**P802.3ca
PAR and Objectives
[Proposed Revision]**

July 2018

Current Timeline

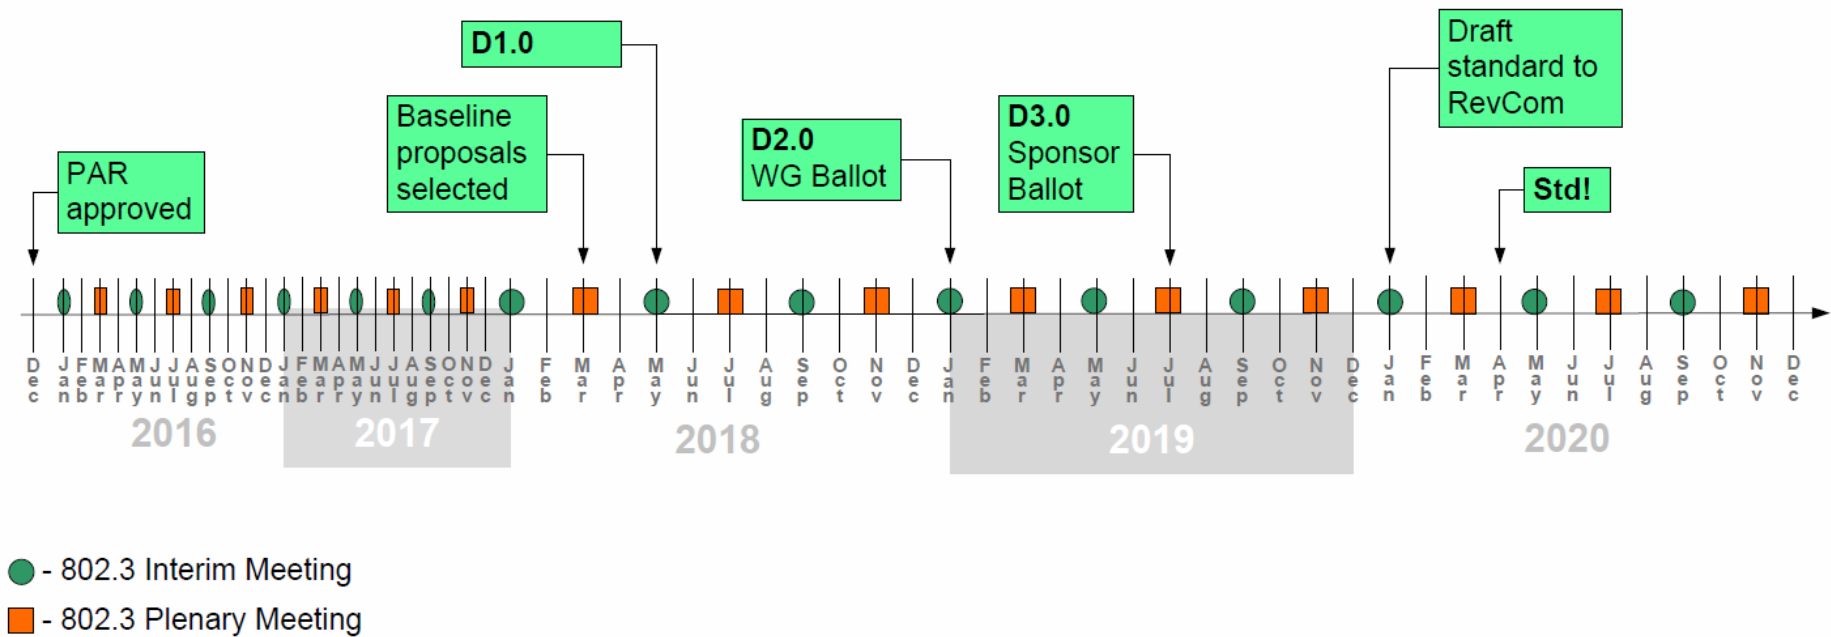
2.1 Title Approved Draft Standard for Ethernet Amendment: Physical Layer Specifications and Management Parameters for 25 Gb/s, and 50 Gb/s, ~~and 100 Gb/s~~ Passive Optical Networks

4.2 Expected Date of submission of draft to the IEEE-SA for Initial Sponsor Ballot: 07/~~2018~~2019

4.3 Projected Completion Date for Submittal to RevCom: ~~05/2019~~ 01/2020

The scope of this project is to amend IEEE Std 802.3 to add physical layer specifications and management parameters for ~~symmetric and/or asymmetric operation at 25 Gb/s, 50 Gb/s, and 100 Gb/s MAC data rates on~~ point-to-multipoint passive optical networks ~~supporting MAC data rates of 25 Gb/s or 50 Gb/s in the downstream direction and 10 Gb/s, 25 Gb/s, or 50 Gb/s in the upstream direction~~, with distance and split ratios consistent with those defined in IEEE Std 802.3-2015.
